Access Compliance Report

Public Rights-of-Way

Intersection ID: 24503	Main Street: BRUFF_CT	Cross Street: SAINTFIELD_PL	Location: SW
ADA ID: 357F92EEE61B	Ramp Type: Perp	Initial Pass/Fail: Fail	Overall Compliance: No
		Severity Score: 17.5

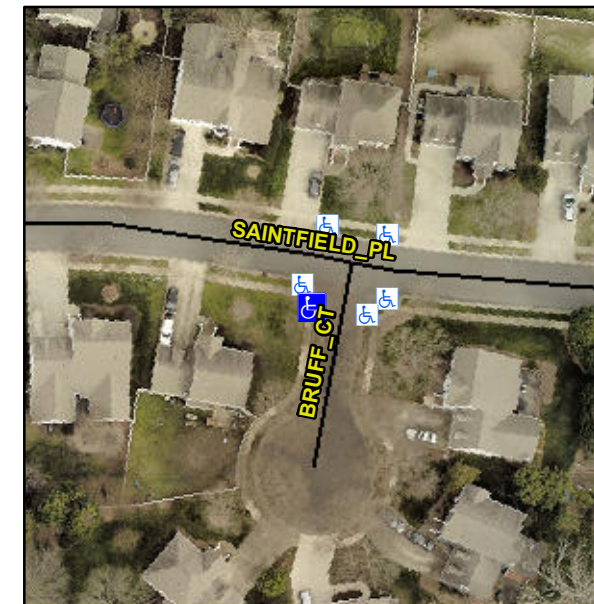
Compliance	Description	Data	Compliance	Description	Data
N/A	Ramp Length (in)	45.0	Yes	Ramp Slope (%)	6.3
No	Ramp Width (in)	35.0	Yes	Ramp XSlope (%)	1.3
N/A	Flare Type LT	N/A	N/A	Flare Type RT	N/A
N/A	Flare Slope LT (%)	N/A	N/A	Flare Slope RT (%)	N/A
N/A	Flare Traversable LT?	N/A	N/A	Flare Traversable RT?	N/A
N/A	Landing Length (in)	N/A	N/A	DWS Provided?	N/A
N/A	Landing Width (in)	N/A	N/A	DWS Contrast?	N/A
N/A	Landing Slope (%)	N/A	N/A	DWS Length (in)	N/A
N/A	Landing X Slope (%)	N/A	N/A	DWS Full Width?	N/A
N/A	Landing Curb? (Y/N)	N/A	N/A	DWS Offset (in)	N/A
N/A	Shared Landing?	N/A			
N/A	Gutter Ponding?	N/A	N/A	Gutter Slope (%)	N/A
N/A	Gutter Lip Ht (in)	N/A	N/A	Gutter X Slope (%)	N/A
N/A	Painted X Walk1?	No	N/A	Painted X Walk2?	N/A
	X Walk 1 Direction	To E		X Walk 2 Direction	N/A
N/A	X Walk 1 Width (in)	N/A	N/A	X Walk 2 Width (in)	N/A
	X Walk 1 Slope (%)	1.8		X Walk 2 Slope (%)	N/A
	X Walk 1 X Slope (%)	0.7		X Walk 2 X Slope (%)	N/A

N/A	Ramp inside XWalk1?	N/A	N/A	Ramp inside XWalk2?	N/A
	Road Slope (%)	N/A	N/A	Clear Space?	N/A
	Road X Slope (%)	N/A	N/A	Clear Space to XWalk (in)	N/A
N/A	Any Obstructions?	N/A	N/A	Storm Grate/Utility Hazard?	N/A
	Obstruction Type			Storm Grate/Utility Type	
		N/A			N/A
			Yes	Surface Condition? (G/P)	Good

Possible Solutions:

Remove & Replace Entire Ramp.

R304.5.1
